TRANS/WP.29/GRSP/2000/2
23 February 2000

World Forum for Harmonization of Vehicle Regulations (WP.29)

PROPOSAL FOR DRAFT AMENDMENTS TO REGULATION No. 44
(Child restraint systems)

Transmitted by the Expert from Sweden

Figure 2

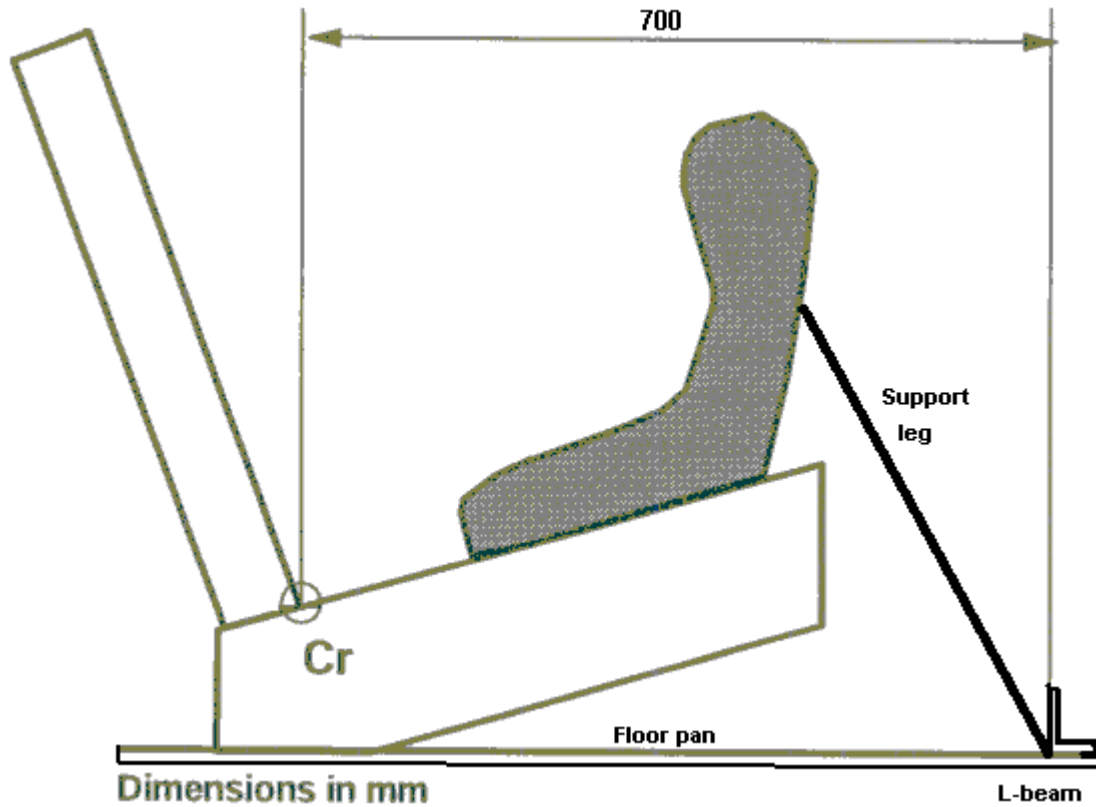
- 1.2.1. The floor pan of the test trolley shall be constructed of a flat sheet of metal of uniform thickness and material, which is designed to withstand a surface pressure of 3 kN per square centimetre without permanent deformation occurring.
- 1.2.2. It shall withstand a vertical point load of 5 kN without permanent deformation occurring.
- 1.2.3. It shall be rigidly bolted or seam welded to the corresponding trolley structure.
- 1.2.4. It shall have a surface irregularity not exceeding Ra 6.3.
- 1.2.5. A beam of metal L-profile shall be fitted transversely to the trolley floor pan 700 mm ahead of line Cr in order to act as a rest for the supporting leg and simulate the front seat rear structure. The flat surface of the L-profile shall be facing the child restraint system. (See figure 2 to this annex.)

The L-profile beam shall have a length of 500 mm \pm 0.5 mm, width of 40 mm \pm 0.5 mm, height of 40 mm \pm 0.5 mm, and a minimum thickness of 5 mm.

The L-profile beam shall be rigidly welded or bolted to the trolley floor pan. If bolts are used, this shall be done with at least 3 M10 bolts.

Insert a new figure 2, as follows:
